TIDAL INPUT 0.25 DEG C/VOLT

Change Summary:

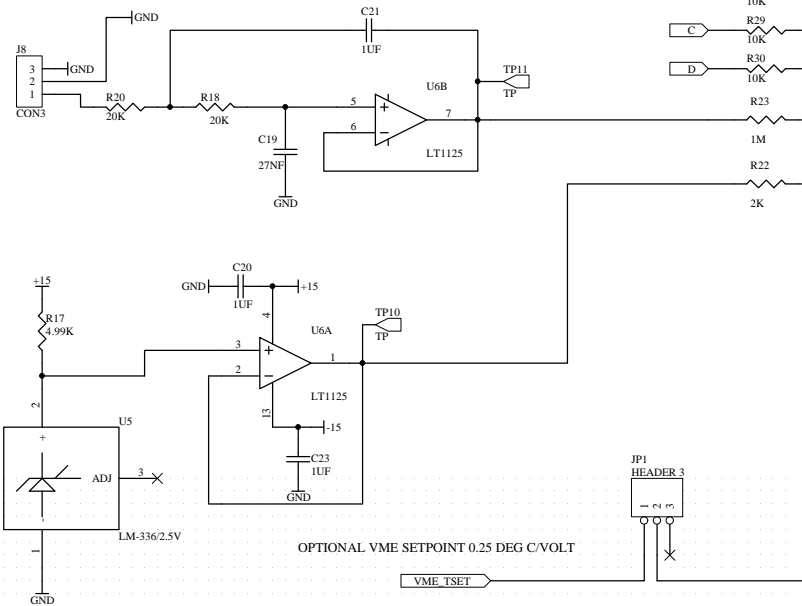
- Needs a resistor to ground (10K) on the tidal input so that it doesn't float up when not connected.
